INDIANA DEPARTMENT OF TRANSPORTATION

FINAL DRAFT MINUTES

March 16, 2017 Standards Committee Meeting

RE: Minutes from the March 16, 2017 Standards Committee Meeting

404-2.03(02) Permanent Metal Forms [Rev. May 2013, Rev. Mar. 2017]

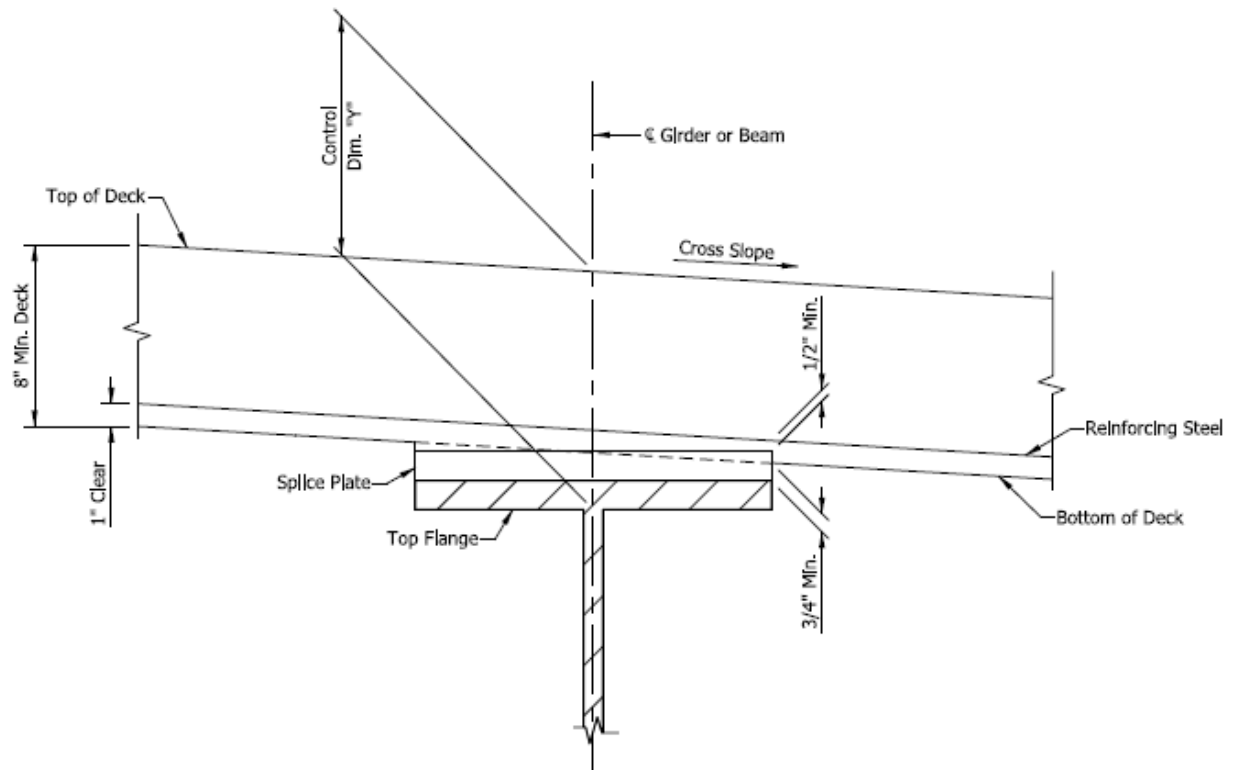
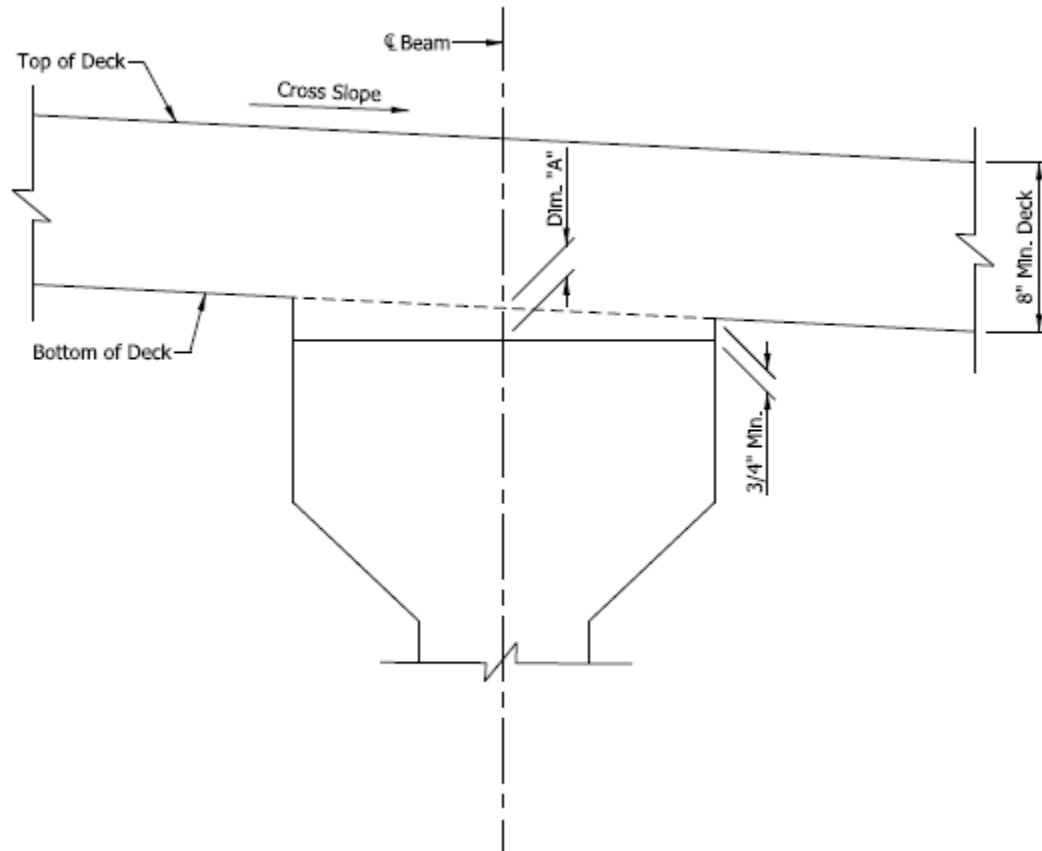
Mr. Orton, sitting in for Ms. Phillips, introduced this item stating the intention to create an RSP to limit the angle leg projection relative to the SIP form pan, and to revise the deflection requirements to be in accordance with AASHTO guidance. Ms. Wagner provided further clarification of the proposed revisions.

PROPOSED SOLUTION: Create an RSP to limit the angle leg projection relative to the SIP form pan. Revise deflection requirements to align with AASHTO guidance.
